dsPIC33EPXXXGM3XX/6XX/7XX Family Silicon Errata and Data Sheet Clarification

The dsPIC33EPXXXGM3XX/6XX/7XX family devices that you have received conform functionally to the current Device Data Sheet (DS70000689D), except for the anomalies described in this document.

FIGURE 1: TIMING DIAGRAMS FOR CENTER-ALIGNED AND EDGE-ALIGNED MODES

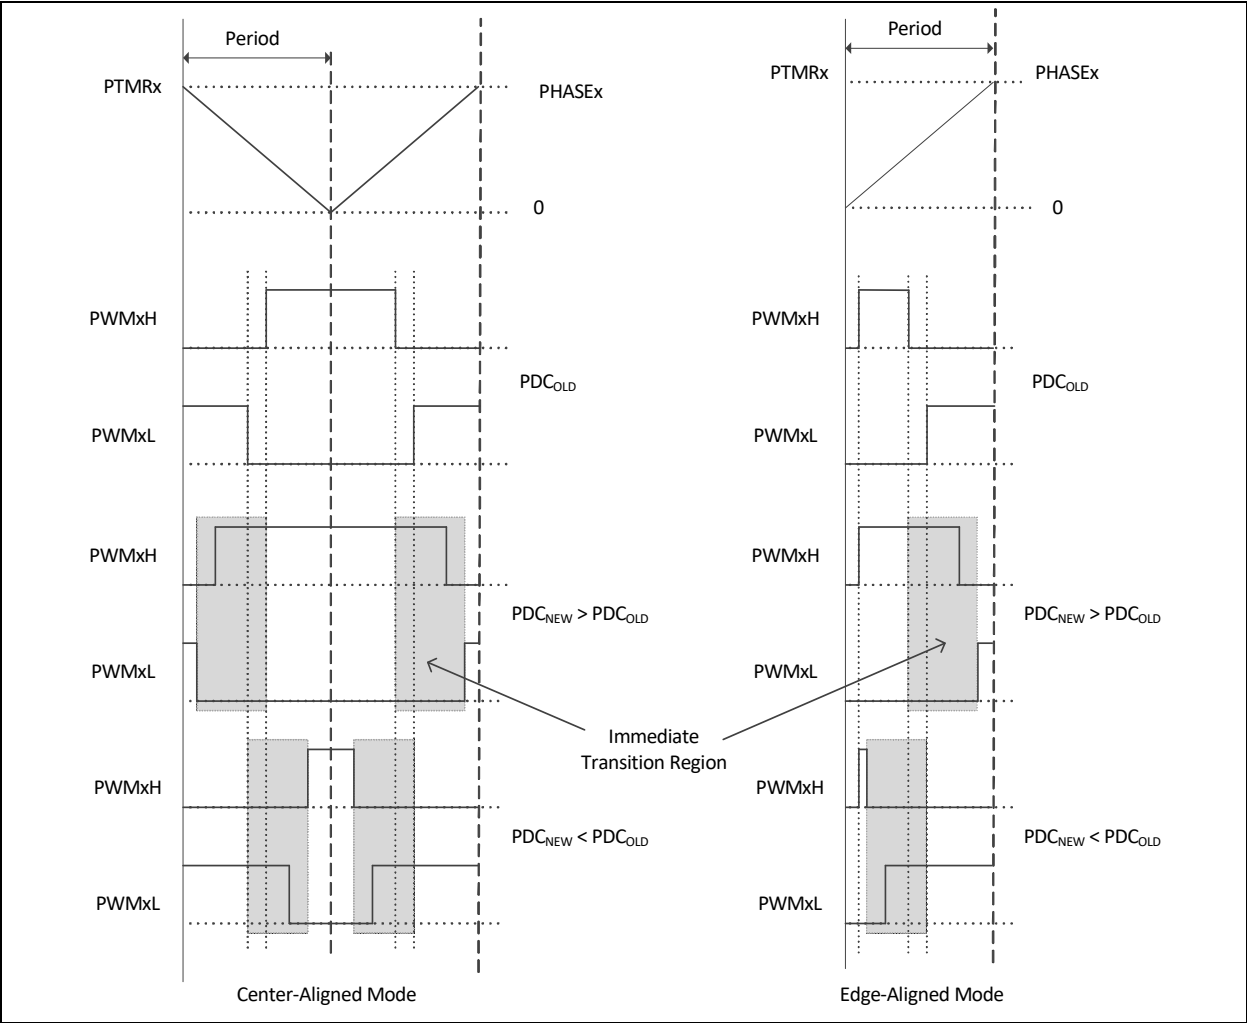
The PWM generator may not assert dead time on the edges of transitions. This has been observed when all of the following conditions are present:

- The PWM generator is configured to operate in Complementary mode with Independent Time Base (ITB) or master time base;
- Immediate update is enabled; and
- The value in the PDC register is updated in such a manner that the PWMxH and PWMxL outputs make an immediate transition.

In Figure 1, if the duty cycle write occurred in the shaded box, then PWMxH and PWMxL will make an immediate transition without dead time.

In most applications, the duty cycle update timing can be controlled using the TRIGx trigger, or Special Event Trigger, such that the above mentioned conditions are avoided altogether.

FIGURE 2: PWM GENERATOR TIMING DIAGRAM

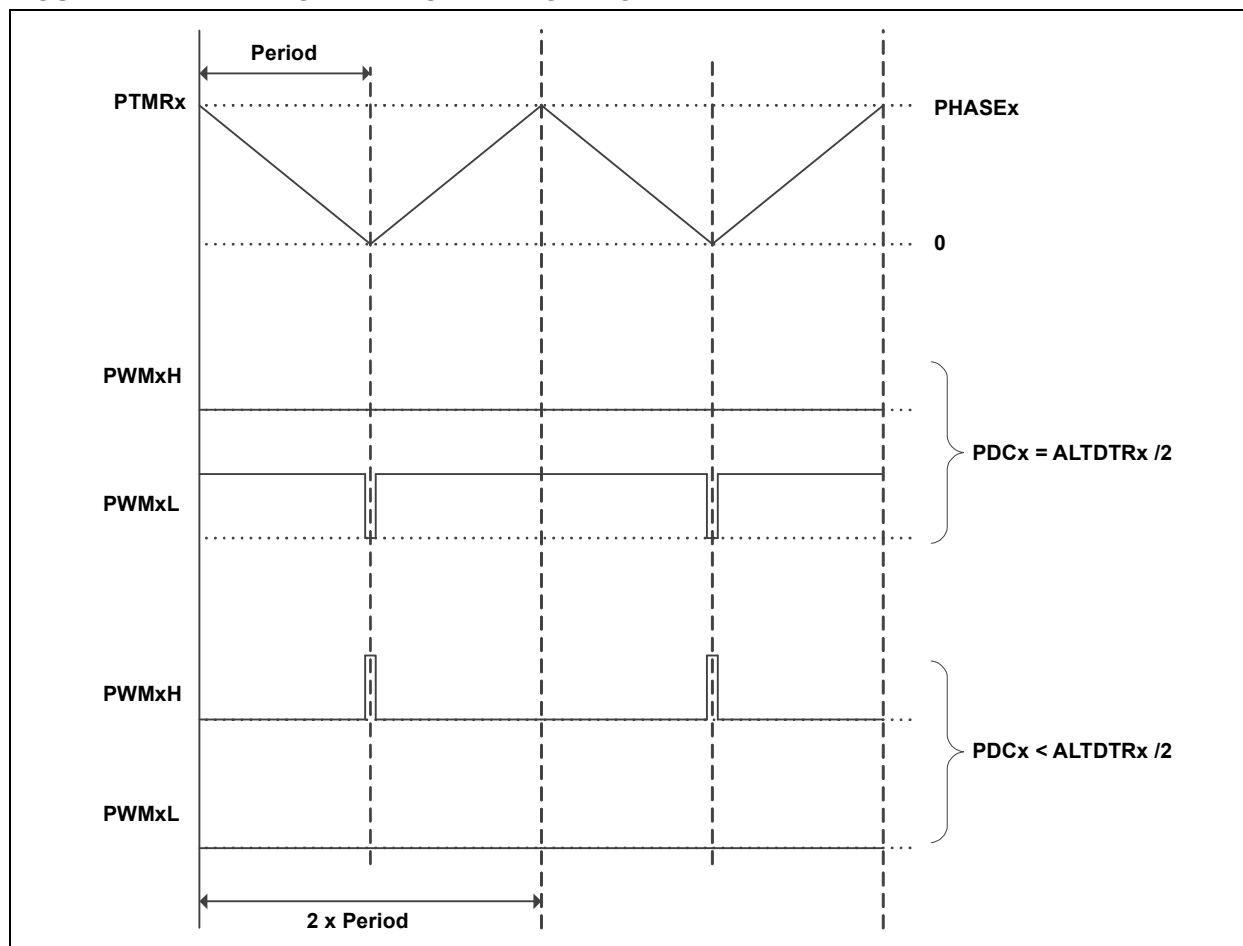
In Center-Aligned Complementary mode with Independent Time Base, if the value in the PDCx register is less than one-half the value in the ALTDTRx register, the PWM generator will force the PWMxL to low, and on the PWMxH, generates pulses of a width less than twice the dead time, as shown in Figure 2.

Include a software routine to ensure that the duty cycle value written to the PDCx register is at least one-half of the value in ALTDTRx. Example 1 shows one method, with PDCtemp representing the variable which has the value to be written to the PDCx register. Alternatively, for duty cycle values less than half the desired dead-time value, zero out the ALTDTRx register or dynamically reduce the value in the ALTDTRx register, such that ALTDTRx is always equal to $2 * PDCx$, as shown in Example 2.

FIGURE 3:

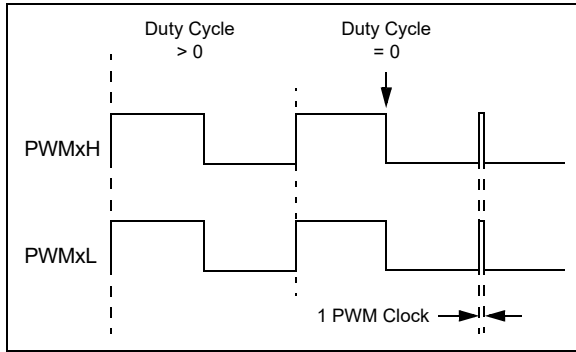
In certain output modes, the PWMx module produces a pulse glitch of one PWM clock in width (Figure 3). This has been observed only when all of the following are true:

- Either Redundant or Push-Pull Output mode is selected (IOCONx[11:10] = 10 or 01);
- Immediate Update is disabled (PWMCONx[0] = 0); and
- The value of the current Duty Cycle register (either the PDCx or MDC register, as determined by PWMCONx[8]) is updated to zero from any non-zero value.

The pulse glitch has been observed to occur at the beginning of the following PWM boundary period.

If the application requires a duty cycle of zero, two possible work arounds are available.

1. Use the PWM overrides to force the output to a low state, instead of writing a '0' to the Duty Cycle register. When using this method, the PWM override must be disabled when the duty cycle is a non-zero value. If output override synchronization is configured to occur on CPU clock boundaries (IOCONx[0] = 0), enabling and disabling the override must be timed to occur as closely as possible to the PWM period boundary.
2. Configure the module for Immediate Update (PWMCONx[0] = 1) *before* enabling the module. In this mode, writes to the Duty Cycle register have an immediate effect on the output. As with the previous work around, writes to the Duty Cycle register must be timed to occur as close to the PWM period boundary as possible in order to avoid distortion of the output.

FIGURE 4:

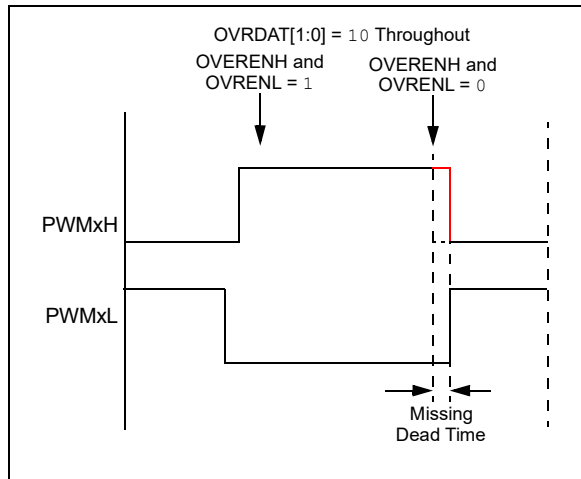
In Complementary Output mode, the expected dead time between transitions of the PWMxH and PWMxL outputs may not be asserted when the following occurs:

- Output override synchronization is configured to occur on the CPU clock boundary (IOCONx[0] = 0);
- Both PWMxH and PWMxL overrides are enabled prior to the event (OVRENH and OVRENL are both '1'), and
- Both overrides are disabled (OVRENH and OVRENL are both '0') at the instant the dead time should be asserted (Figure 4).

This has been observed in both Center-Aligned and Edge-Aligned modes.

FIGURE 5:

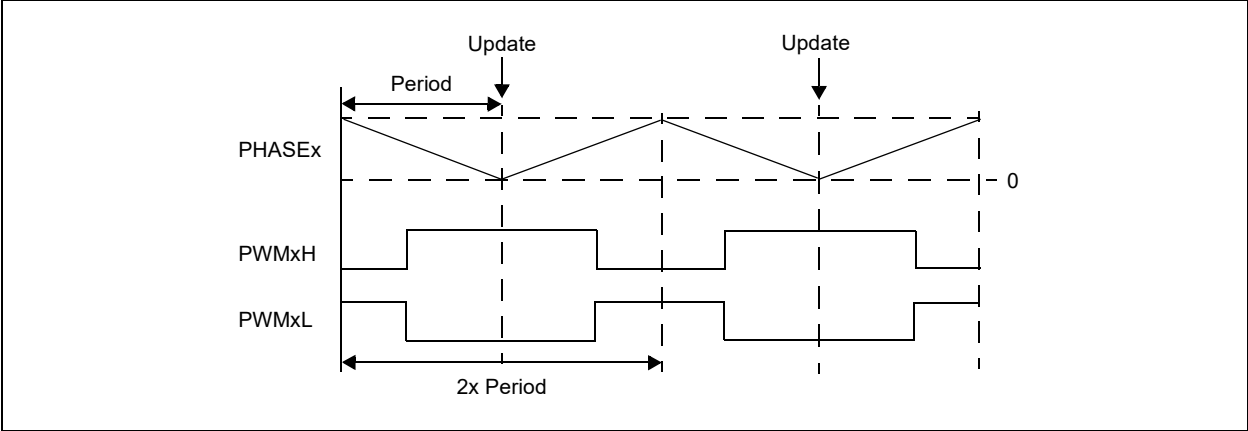
In Center-Aligned Complementary mode with Independent Time Base, updates to the PHASEx register take effect in the middle of a Center-Aligned PWM cycle, as shown in Figure 5. This occurs only when the Immediate Update feature is disabled (IUE = 0). If Immediate Update is enabled (IUE = 1), the PHASEx register updates will take effect immediately.

FIGURE 6:

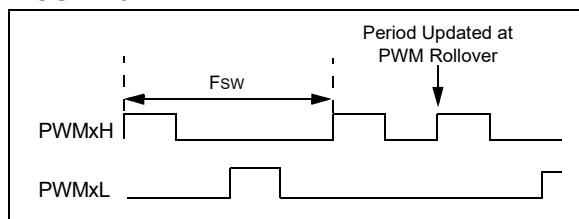
When the PWM module is configured for Push-Pull mode (IOCONx[11:10] = 10) with the Enable Immediate Period Update bit enabled (PTCON[10] = 1), a write to the Period register that coincides with the period rollover event may cause the push-pull output logic to produce back-to-back pulses on the PWMx pins (Figure 6).

Ensure that the update to the PWM Period register occurs away from the PWM rollover event by setting the EIPU bit (PTCON[10] = 1). Use either the PWM Special Event Trigger (SEVTCMP) or the PWM Primary Trigger (TRIGx) to generate a PWM Interrupt Service Routine (ISR) near the start of the PWM cycle. This ISR will ensure that period writes do not occur near the PWM period rollover event.

FIGURE 7: SIMPLIFIED BEHAVIOR

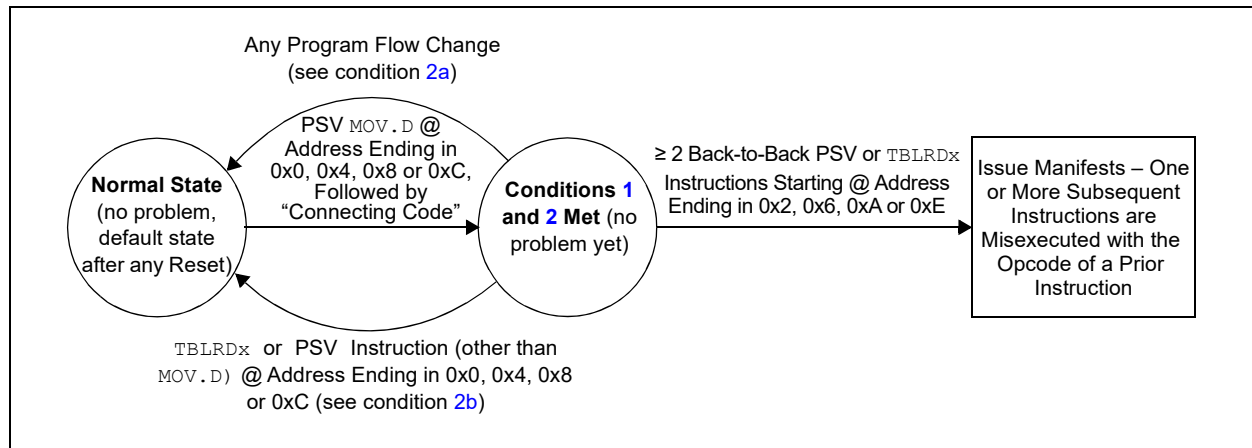
3.	≥ 2 back-to-back PSV or <code>TBLRDx</code> instructions are executed (following the code of condition 2), where the first of the back-to-back instructions is located at an address ending in 0x2, 0x6, 0xA or 0xE.

[Figure 7](#) provides an example of the effective behavior.

1. All instances of PSV `MOV.D` can be replaced with two PSV `MOV` instructions instead. Non-PSV `MOV.D` instructions acting on RAM/SFRs do not need to be modified; or
2. If not already present, a program flow change instruction (such as `BRA $+2`) can be inserted above back-to-back data Flash read sequences; or
3. Back-to-back data Flash read instruction sequences can be broken up by inserting a non-Flash read instruction (such as a `NOP`), in between the Flash read instructions; or
4. The alignment of the code can be shifted to avoid the required opcode location addresses.

C code built with MPLAB® XC16 Compiler Version 1.32, or later, implements the work around by default. However, if the application uses Assembly language routines, these should be manually modified to implement the work around. Additionally, if precompiled libraries are used, these should be built with XC16 Version 1.32 or later. For additional information, please visit: www.microchip.com/erratum_psrds_psrds

64-Lead Plastic Quad Flat, No Lead Package (MR) – 9x9x0.9 mm Body with 5.40 x 5.40 Exposed Pad [QFN]

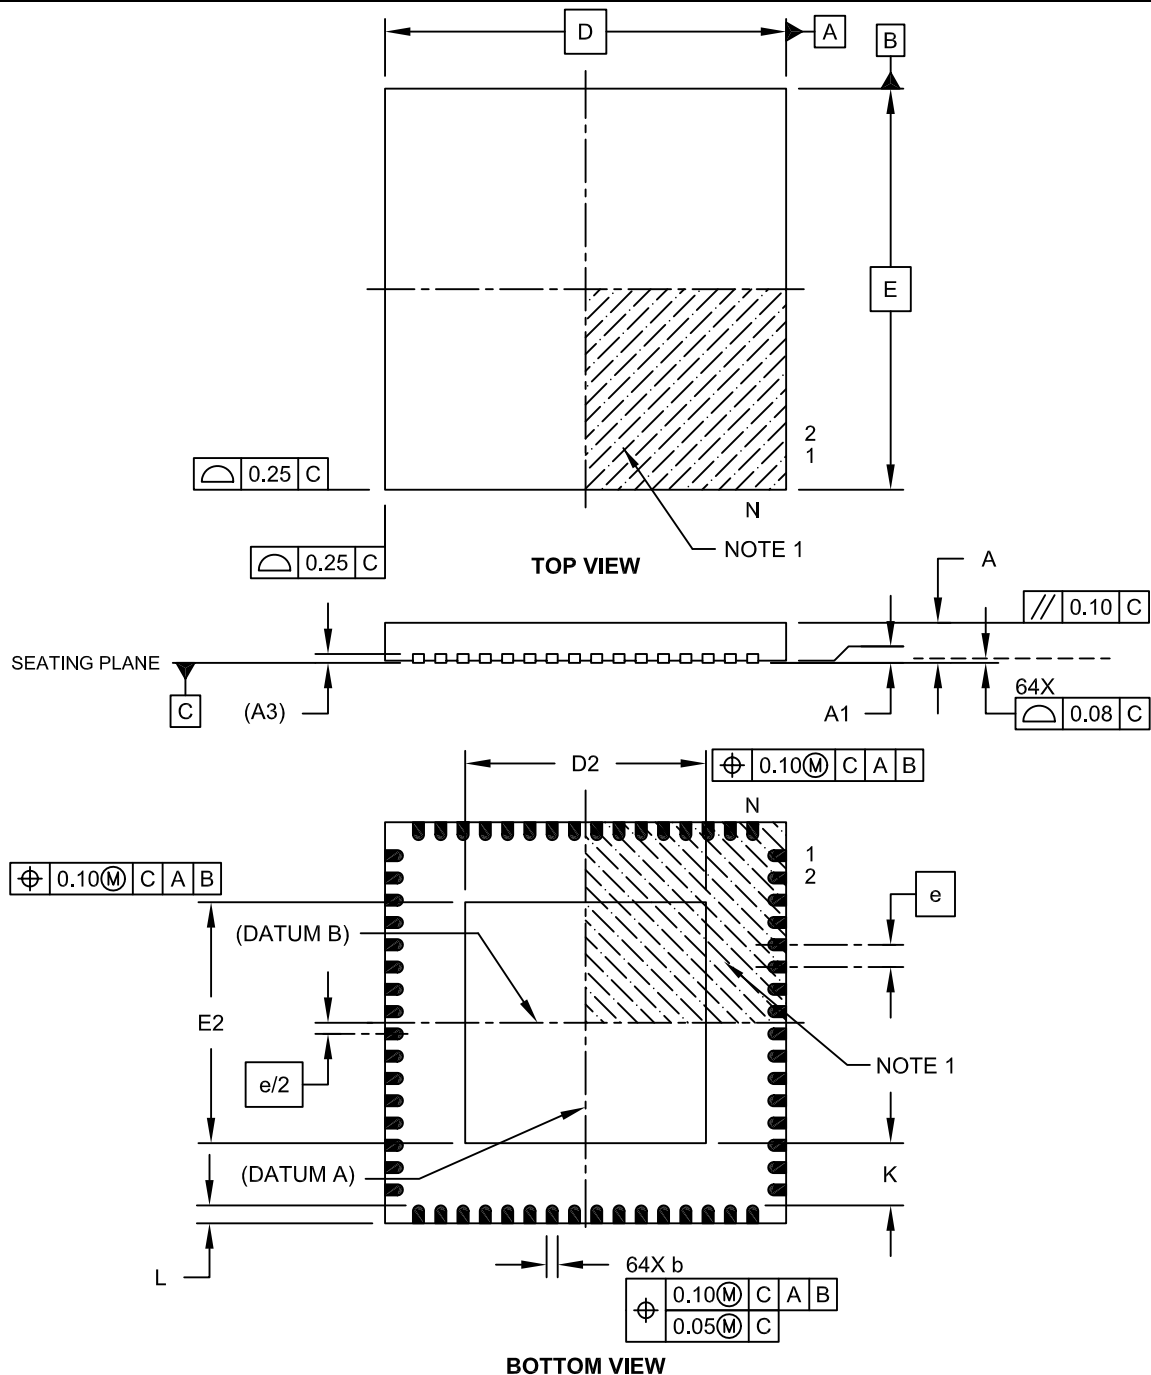
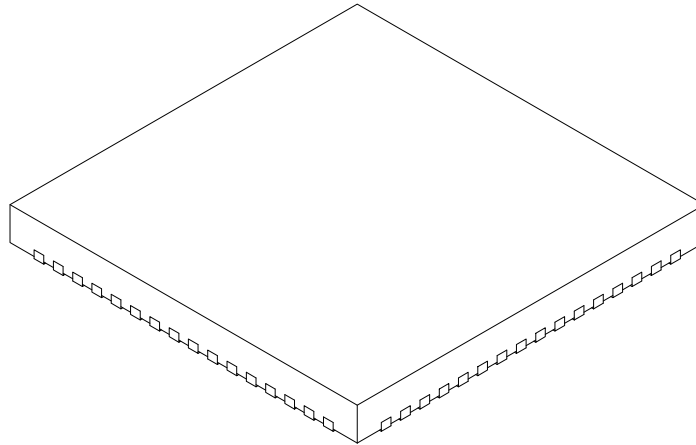
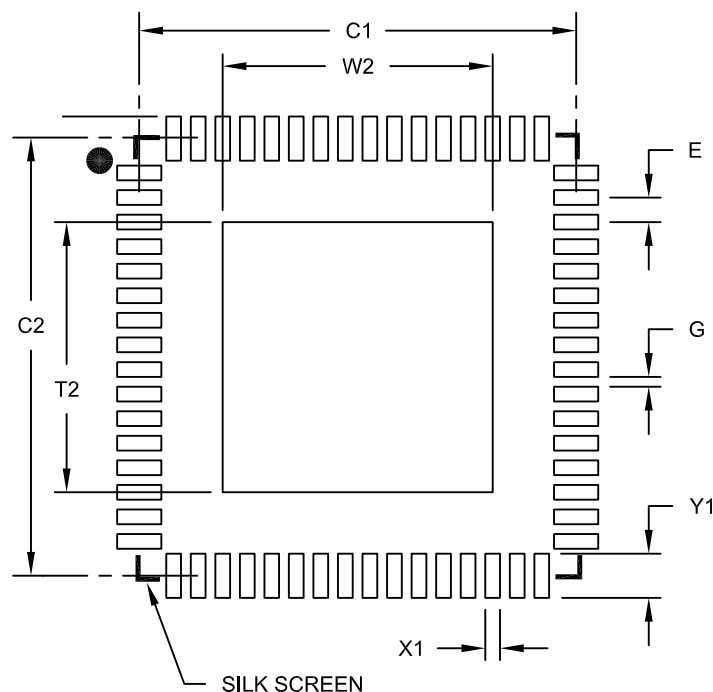
In the “dsPIC33EPXXXGM3XX/6XX/7XX Family Data Sheet”, **Section 35.2 “Package Details”**, dimensions for the 64-Lead Plastic Quad Flat, No Lead Package (MR) – 9x9x0.9 mm Body with 7.15 x 7.15 Exposed Pad [QFN] is mentioned. However, the dsPIC33EPXXXGM3XX/6XX/7XX family devices are not available in this package.

The dsPIC33EPXXXGM3XX/6XX/7XX family devices are available in the 64-Lead Plastic Quad Flat, No Lead Package (MR) – 9x9x0.9 mm Body with 5.40 x 5.40 Exposed Pad [QFN], and the package dimensions are shown on the following pages.
